EPC Package for Singrauli STPP Stage-III (2x800 MW)

S No	BID SPECIFICATION				SPECIFICATION REQUIREMENT	Pre-Bid Queries/ Clarifications	Reply
	Section	Sub-Section	Page No.	Clause No.			
27	SECTION – VI, PART-F	SUB-SECTION-VI CHAPTER -01	PAGE 5 OF 39	1.05.00 Fans A. ID Fans Sl no:10.0	ID fan impeller liner	Impeller liners and Casing liners are not applicable for Axial Reaction ID Fans as per bidder's design practise followed in all the super-critical 660 MW, 800 MW TPP's executed by bidder's for NTPC. These spares are applicable for Radial ID Fans offered in Sub-critical 500 MW Projects. Accordingly, no item is offered against this clause in the previous super-critical 660MW, 800 MW TPP projects of NTPC executed by bidder's. NTPC may please modify the requirement including the clause with "if applicable" similar to amendment issued for SCCL 1x800 MW tender or else delete this requirement. This amendment is critical for smooth execution of contract as functionally equivalent spare item cannot be offered against this requirement.	Bidder to refer Amendment no SG.18 and SG.19 in this regard.

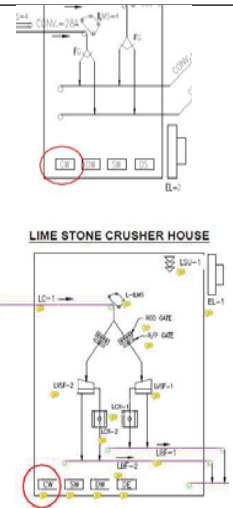
SECTION-VI, PART-E	LIST OF TENDER DRAWINGS	PAGE 54 OF 130	GYPSUM FLOW DIAGRAM			
90	SECTION-VI, PART-E	LIST OF TENDER DRAWINGS	PAGE 56 OF 130	COAL AND BIOMASS DIAGRAM 9587-001(R)-POM-A-002 RevA	In coal crusher house 	With the existing space and layout constraints, it is not feasible to provide 4 nos. belt feeders in coal crusher house. Alternately, bidder is proposing 2 nos. reversible belt feeders (RBF-1 and RBF-2) instead of 4 nos. belt feeders. RBF-1 will take feed from CR-1&2 and RBF-2 will take feed from CR-3&4. RBF-1&2 shall discharge material to direct path on one side and stacking path on other side. Capacity of RBF-1 & 2 shall be 2200 TPH (rated) and 2420 TPH (design) with belt width of 2200mm, speed of 1.65m/sec considering material density as 0.8T/m ³ , fill factor of 0.9 and slope factor of 1 (as it is horizontal). RBF kind of arrangement is already provided in earlier NTPC projects also. So kindly confirm if proposed RBF arrangement is acceptable for Singrauli Stage-III.	Bidder to note that reversible belt feeder is not acceptable.

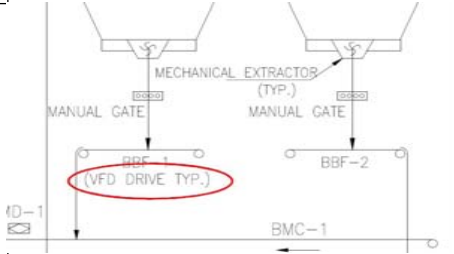
104	SECTION-VI, PART-E	LIST OF TENDER DRAWINGS	PAGE 9 OF 130	GENERAL LAYOUT PLAN		1. As per general layout plan, the existing Silo utility building is fouling with TP-19. TP-19 location cannot be changed due to layout constraints and feasibility.	Bidder to refer Sl. No MH-8 amendment no 1 to technical specification.

2. Existing Silo utility building has to be dismantled and relocated to avoid this fouling. Kindly clarify whether this dismantling and relocation is in NTPC scope or Bidder's scope.

3. In case dismantling and relocation of existing silo utility building is in bidder's scope, please confirm whether the cost of dismantling, relocation and re-erection of the facilities in this existing building should be considered by bidder.	
						Road is fouling with the Coal crusher house in NIT drg., kindly confirm that successful bidder shall have the provision to make required changes in the road	Bidder to refer Sl. No MH-3 & 8 amendment no 1 to technical specification.
